Schweizer Aircraft Corporation
Elmira, New York

SERVICE BULLETIN NO. 102-26-4

SGS 1-26 SEAT BACK

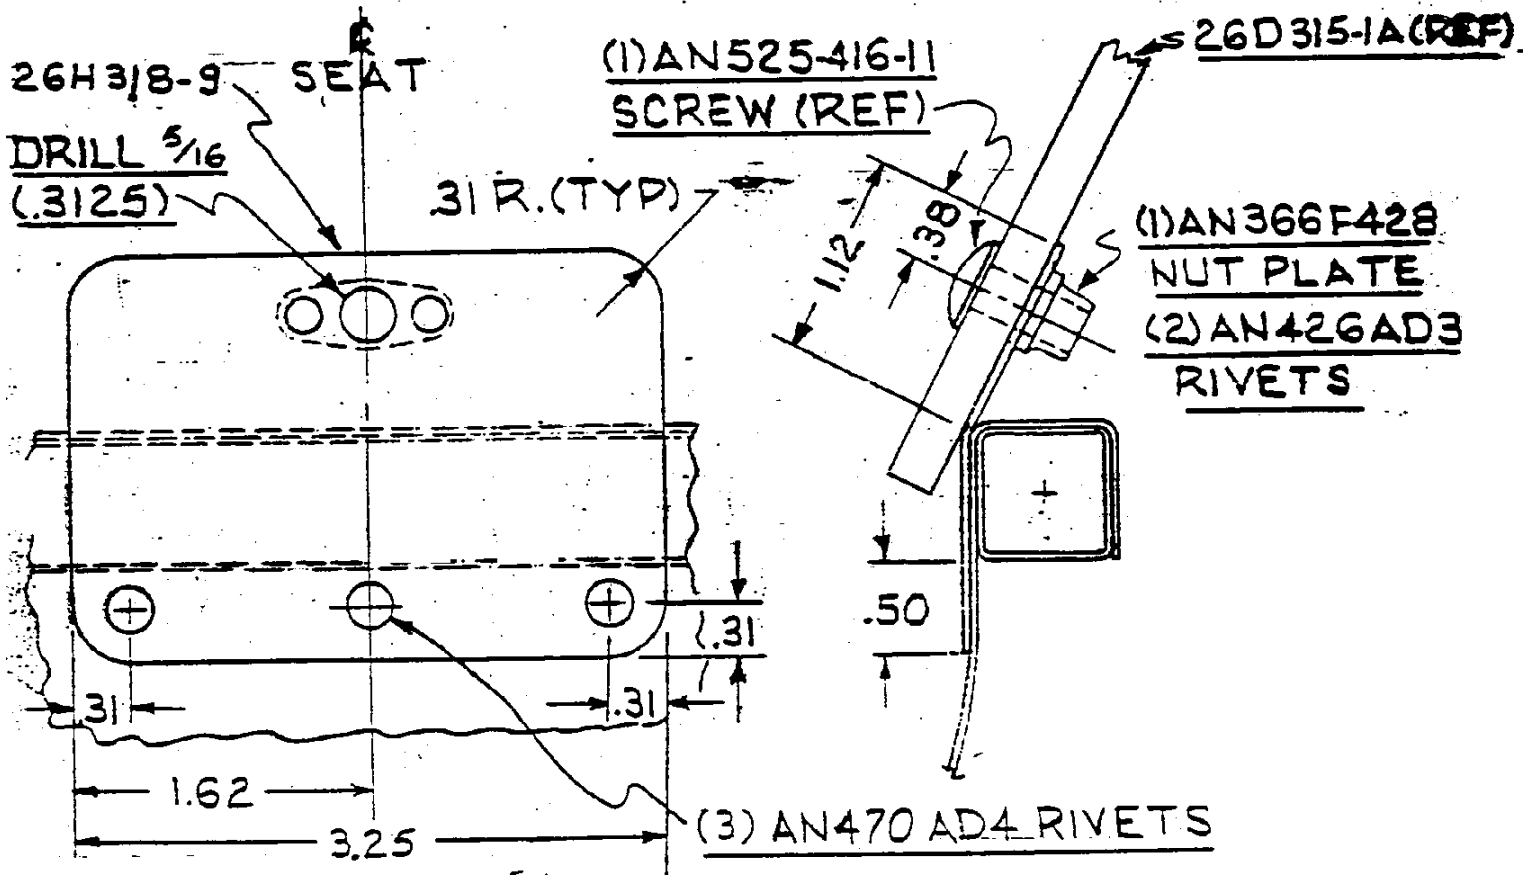
There have been cases reported where the seat back, which is held at the bottom end by aluminum clips, has disengaged and moved back suddenly. This is disconcerting to the pilot and could cause loss of control at a critical flight condition.

It is recommended that as a routine preflight check that this seat back be checked to see that it is secure in its normal position. If the clips, 26D-315-4 are distorted, they should be reworked or replaced. If they are reworked, check carefully for cracks. An alternate design is being investigated and you will be advised if this becomes available.

CHANGE: ^{REV ES 9/10/62} 1. ADD ATTACH. PLATE TO SEAT AS SHN.
MAKE FROM .040 2024-T3 ALC

1. TO PROVIDE ADDITIONAL ATTACHMENT
FOR SEAT BACK.
